**TENNESSEE VALLEY AUTHORITY
BROWNS FERRY NUCLEAR PLANT (BFN)
UNITS 1, 2, AND 3**

**TECHNICAL SPECIFICATIONS (TS) CHANGES TS-431 AND TS-418
EXTENDED POWER UPRATE (EPU)**

**RESPONSE TO ROUND 15 GROUP 4 AND ROUND 17 REQUEST FOR ADDITIONAL
INFORMATION (RAI)**

Figure EMCB.130/97-1: PSD comparison of pressure measurements on MSLs for Unit 1 and Unit 3

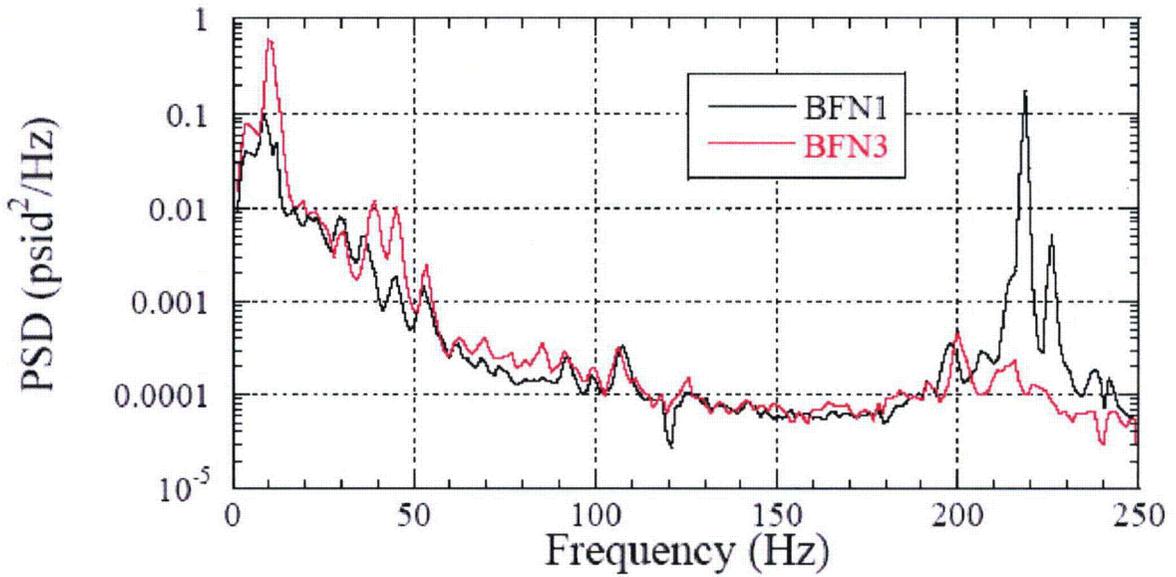
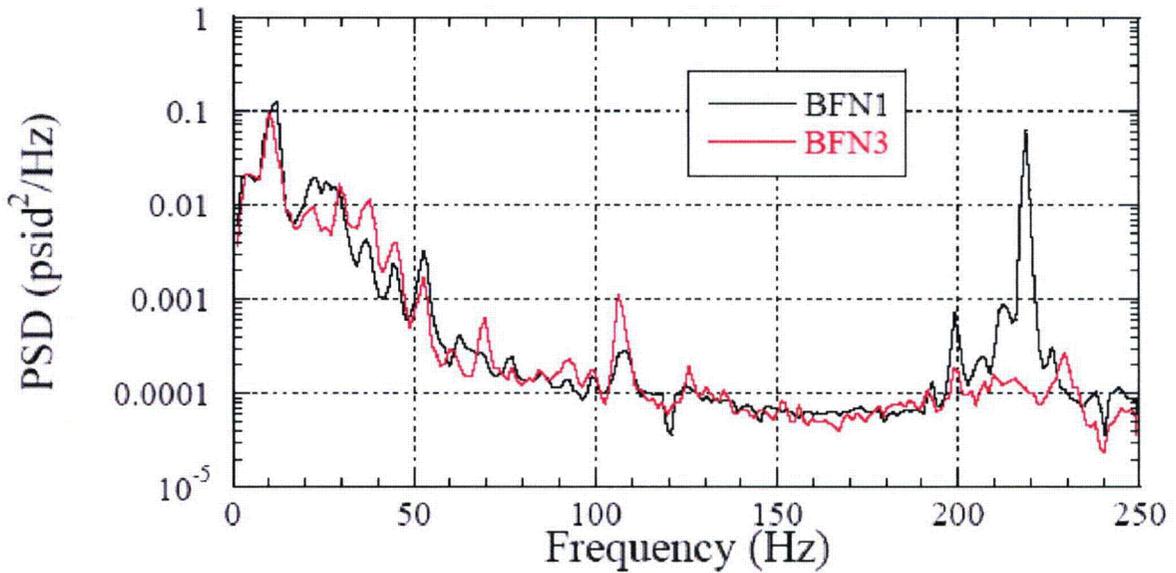
During the upcoming Unit 3 Spring 2008 refueling outage, the eight unused standpipes in MSLs A and D, which are believed to cause strong 218 Hz tones in the plant on Unit 3, will be

plugged. Additionally, the Unit 3 MSLs will be instrumented and the acoustic pressures will be measured. Provide the following information:

- (a) analyses or test reports that explain the nature of the 218 Hz tones, along with the proposed changes to the standpipes and a demonstration that the changes will eliminate the tones;
- (b) a revised stress analysis for Unit 3 based on the Unit 3 MSL strain gage measurements; and
- (c) limit curves for Unit 3 based on the stress results in item (b).

During the recent refueling outage on Unit 3, TVA installed AVSs and MSL strain gages as previously planned. During startup, the MSL strain gages experienced a high rate of failure. The set of operable strain gages (10 of 64) that remain useable is not sufficient to define a Unit 3 specific dryer load using the Acoustic Circuit Model (ACM) needed for performance of the Unit 3 steam dryer analysis as committed; however, they provide data that can be used in the following discussion.

- (a) The nature of the 218 Hz tone, along with the proposed changes to the standpipes, was previously discussed in the reply to EMEB.124/91 in the November 21, 2007 submittal, "Response to Preliminary Findings on Steam Dryer Stress Analysis," (ML073330483).

- (b) Due to the failure of the Unit 3 MSL strain gages, the Unit 3 steam dryer stress analysis cannot be completed as originally scheduled. Since these gages are located in the drywell, necessary repairs will require a plant outage of sufficient duration to allow troubleshooting and replacement of the instrumentation. Following repair of the strain gages, a revised steam dryer stress analysis will be completed utilizing the load definition based on Unit 3 MSL strain gage data. The revised stress analysis will be performed with the same methodology used for the Unit 1 and Unit 2 steam dryer stress analyses.
- (c) Following the completion of the Unit 3 stress analysis discussed in (b) above, Unit 3 steam dryer limit curves will be generated. The method to generate the limit curves will be the same as previously used in the generation of the limit curves for Units 1 and 2.

Figure EMCB.169/137-1: Time History for Drain Channel Unit 2 Node 105514

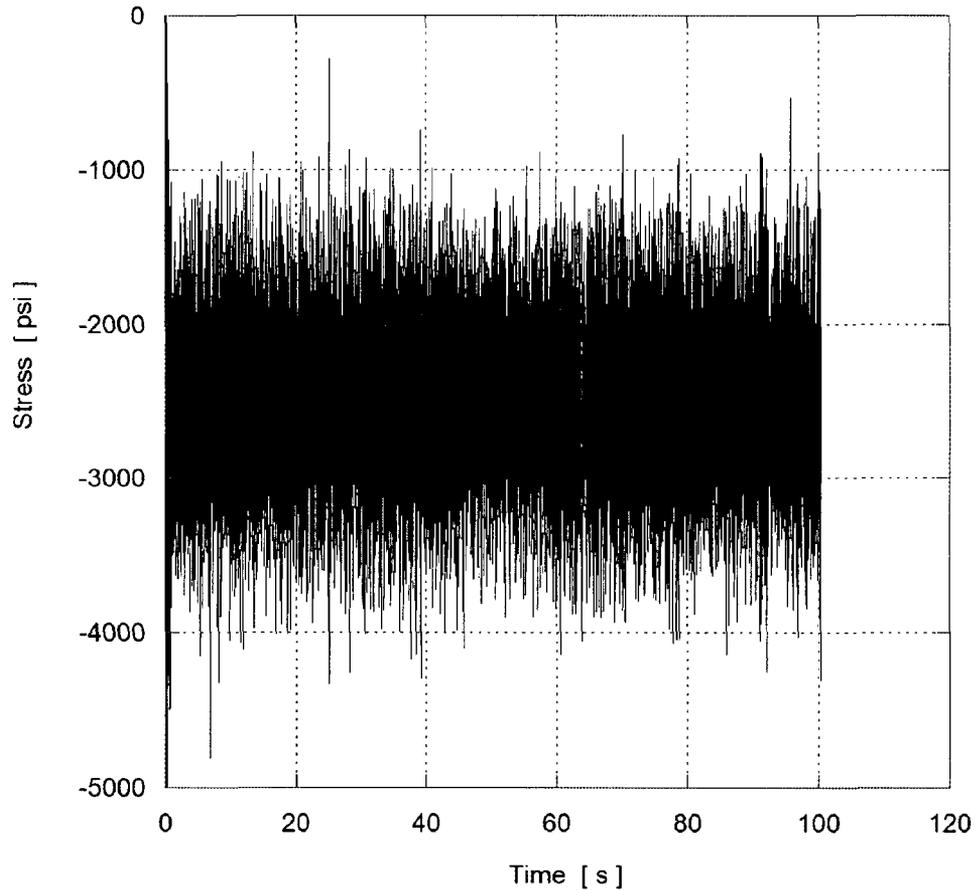
Address why it took so long for the cracking to be observed. Provide time histories of the stress intensities at these three failure locations and identify the frequencies of the highest alternating stress intensities that may be responsible for the observed cracking. Additionally, provide the root cause analyses reports for these three failures.

The stress time history for BFN Unit 2 Node 105514 on the drain channel (see Table EMCB.146/113-1 and Figure EMCB.146/113-9 in the April 4, 2008 submittal) is provided in Figure EMCB.169.137-1. This figure is based upon the Unit 2 stress analysis provided in the April 4, 2008 submittal. This stress analyses does not reflect the original design of steam dryers at the time the drain channel welds were cracked nor does it include the 218 Hz blind flange frequency which is being removed by the installation of the AVSs.

Figure EMCB.170/138-1: Node 88059

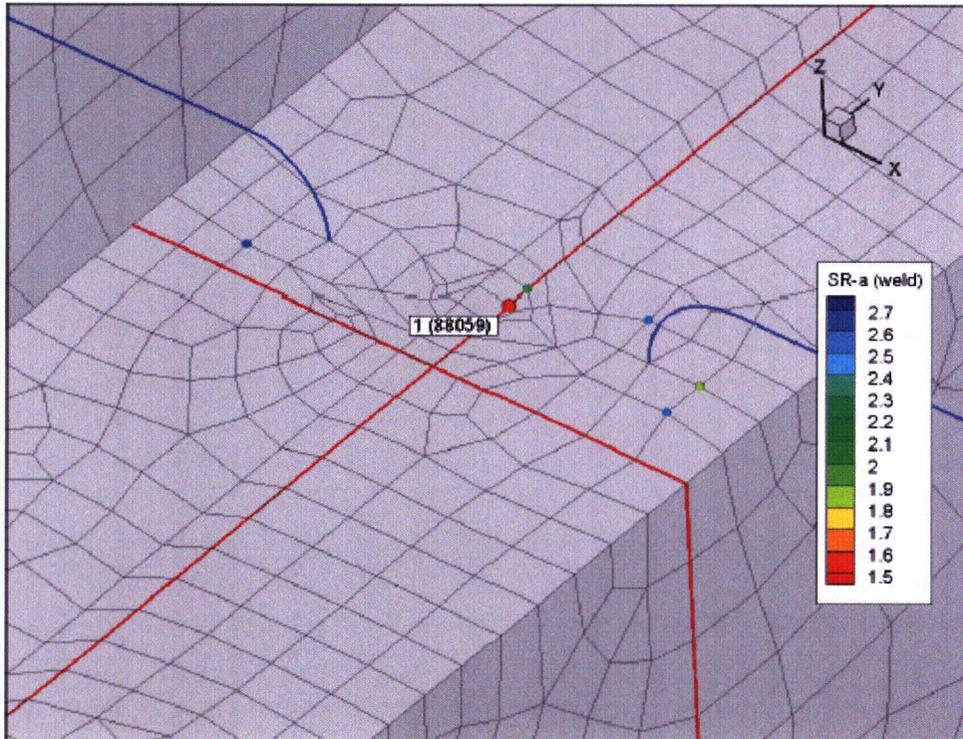
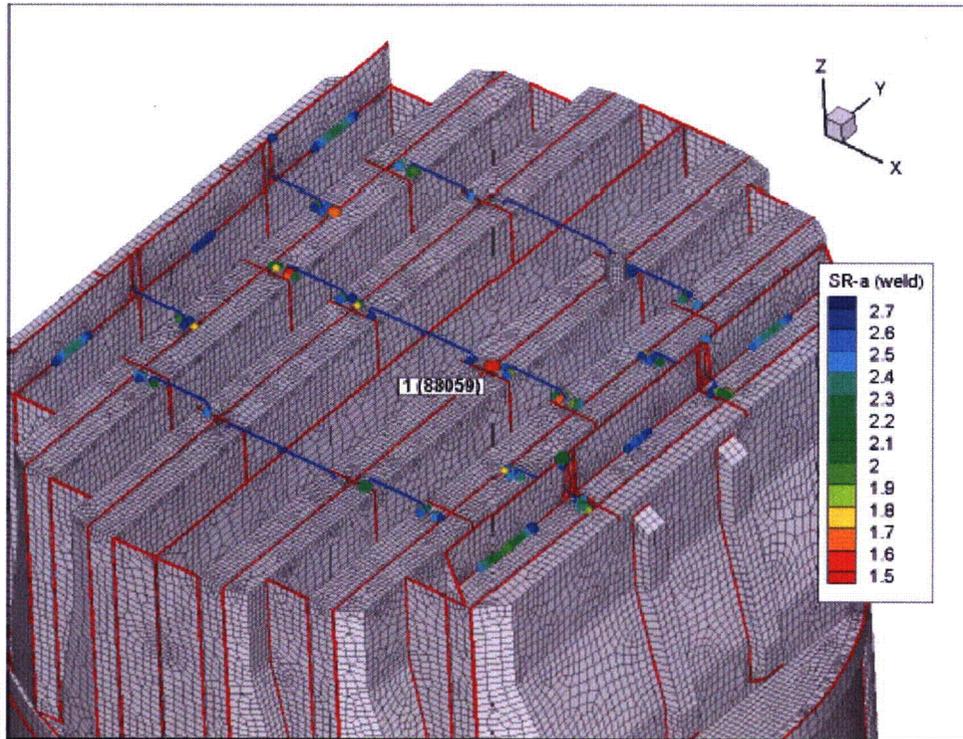
- (a) For the nodes listed in Table EMCB 138/105-1 of the TVA response to EMCB 138/105 and located on shell elements, identify the section location and orientation of these components. For Top Cover/Tie Bar Base locations, discuss whether the plotted stress components act along the length of the tie bar. For locations including tie bars, indicate whether the dominating alternating loads acting on the tie bars are tensile loads or bending moments.

- (a) Figures EMCB.170/138-1 through 14 provide the location and orientation of the nodes with the lowest alternating stress ratios as discussed in the response to EMCB.138/105 in the March 6, 2008 submittal. Table EMCB.170/138-1 provides a correlation of the nodes to the appropriate figure. This table has been expanded from 10 to 14 nodes to facilitate the discussion in the response to RAI EMCB.180 in this submittal.

At Top Cover/Tie Bar Base locations such as shown in Figure EMCB.170/138-1, the stresses are primarily the result of local bending in various orientations in the cover plate adjacent to the tie bar pad plates. None of the locations with the lowest stress ratios is in the tie bars.

Figure EMCB.170/138-1a: Accumulative alternating stress intensity curves for nodes 88,059 and 107,054

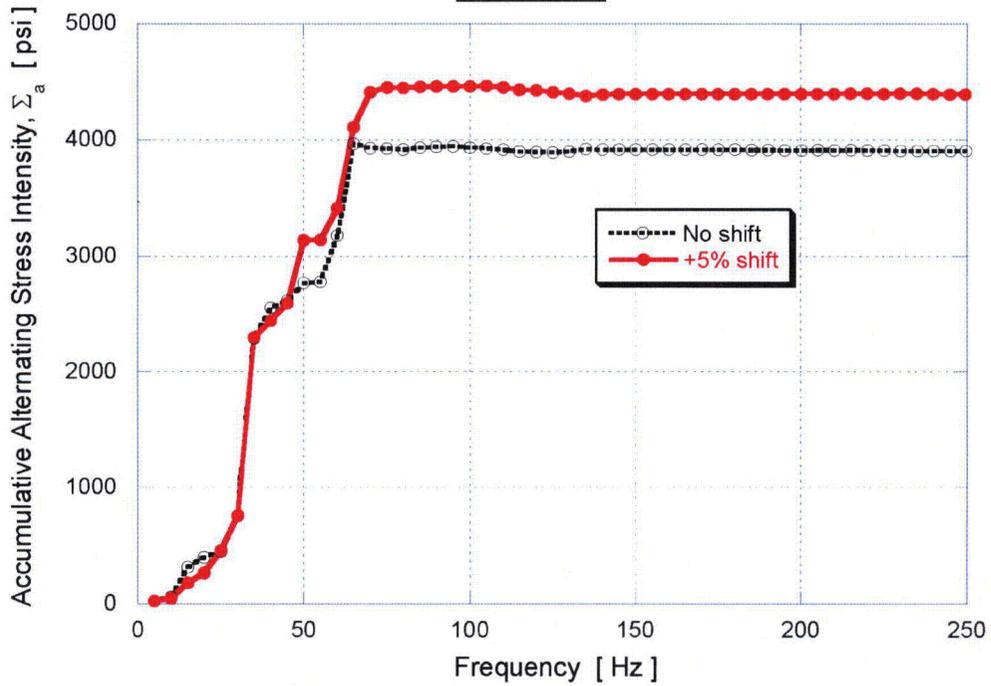
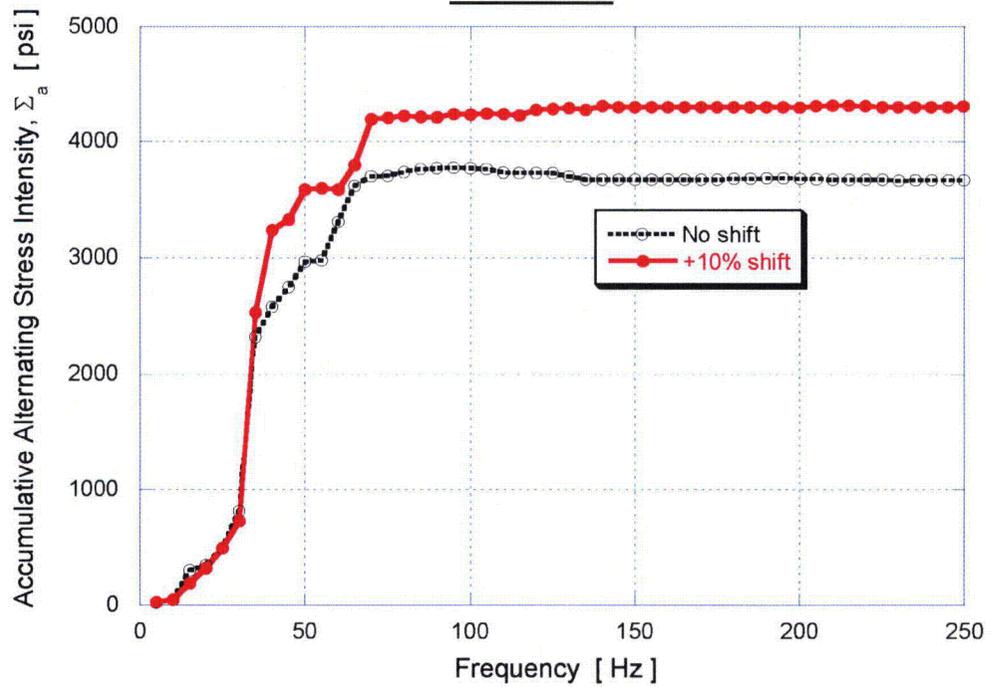
- (b) Provide accumulative power spectral density (PSD) curves of overall stress intensity, rather than individual stress components. Also, provide mode shapes (or unit MSL source driven dryer displacement response shapes) of the dryer at and near the peak stress frequencies of 34, 47, and 62 Hz. The mode shapes should show overall dryer vibration, as well as close-ups of smaller regions with strong vibration. For each mode shape, also show the motion of the perforated plates.

First, it is important to emphasize the purpose and usage of the accumulative PSD curves as used in CDI's reports and previous RAI responses. The primary role is to identify the frequencies where significant stress contributions occur. This information can be obtained by examining PSDs or accumulative PSD curves of any stress component since the generally strong response in one stress component at a given frequency will be mirrored in the other components also due to the 3D coupling between stresses. Identifying the dominant frequencies is useful for both diagnostic work (e.g., determining whether the acoustic loading contains a strong component at the given frequency; inferring damping estimates from the PSD curve in cases with well-separated modes) and corrective design (e.g., limiting initial design analysis to a given frequency range). The PSD and accumulative PSD curves are of more limited value, however, for quantitative stress estimates. For example, it is possible that a frequency shift will increase the alternating stress intensity while reducing the accumulative PSD level. This typically occurs when the stress response exhibits one or a small number of localized peaks so that the peak-to-peak response increases, but the root mean square (RMS) average of the amplitudes shows a much smaller increase. In fact, it is easy to see that the peak-to-peak variation in a stress component will always be larger than the RMS amplitude since for any set of amplitudes, a_i with $i=1$ to N :

Figure EMCB.172-1: PSD comparison of pressure measurements on main steam line A at strain gage locations upper (top) and lower (bottom), for CLTP and 9% power conditions.

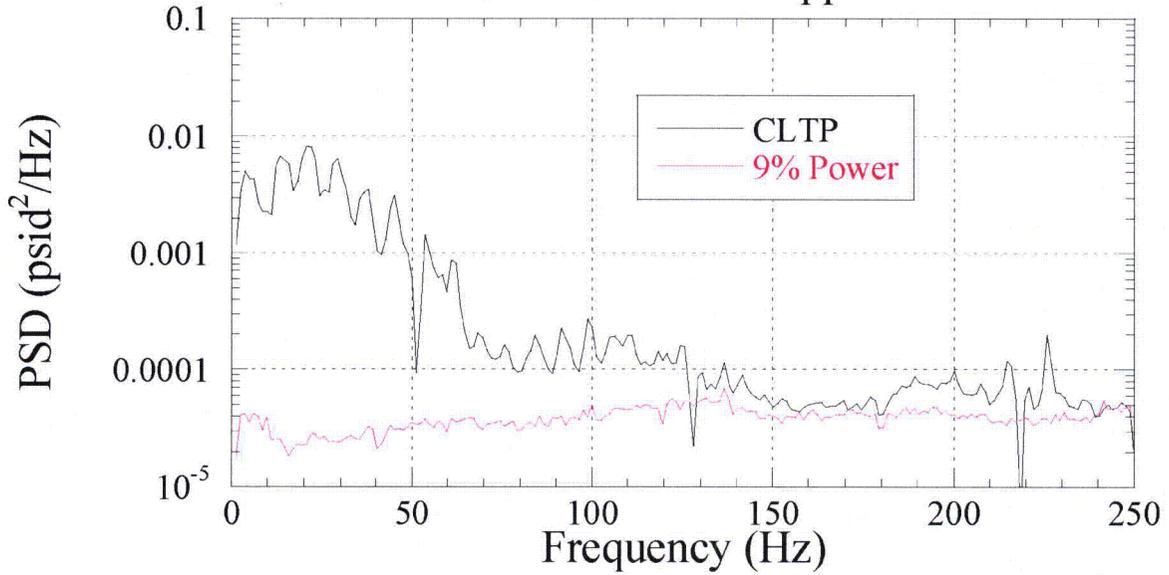
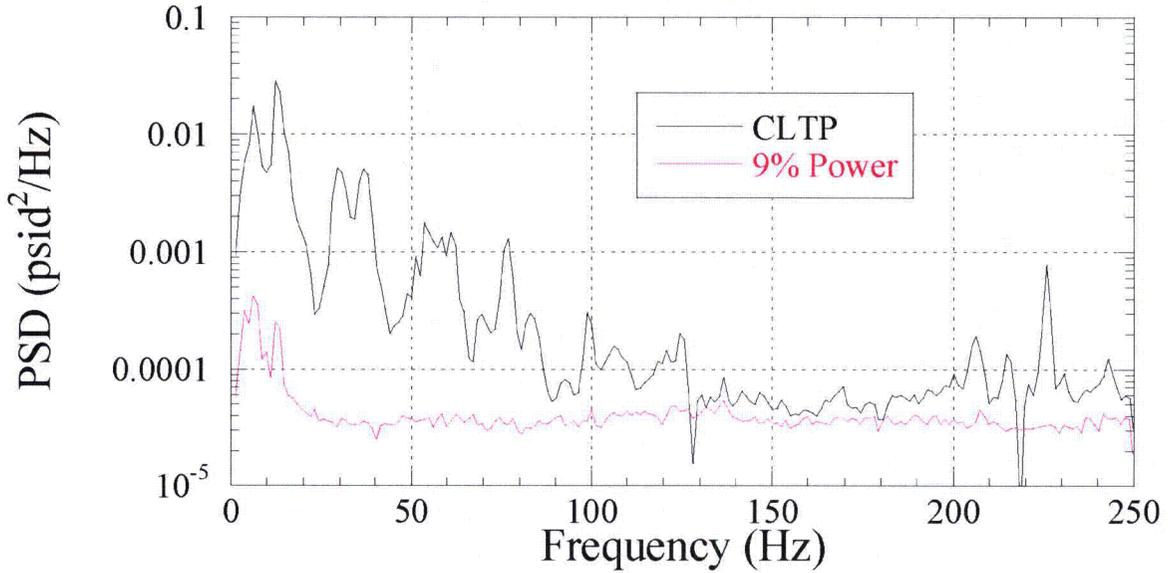
- (a) Provide the following for Unit 1:
- (i) Plots comparing MSL strain gage PSDs for current licensed thermal power (CLTP) (without low-flow background noise removal), low-flow conditions, and CLTP (with low-flow background noise removal).
 - (ii) Plots similar to those in (a), [[

- (a) The following figures are provided.
 - (i) Figures EMCB.172-1 through 4 provide the MSL strain gage PSDs for CLTP (without low-flow background noise removal) and low flow conditions at each of the MSL strain gage locations. Noise is removed at the MSL inlets and not at the MSL strain gage signals. Therefore, a plot of the MSL strain gage PSDs for CLTP (with low-flow background noise removal) does not exist.
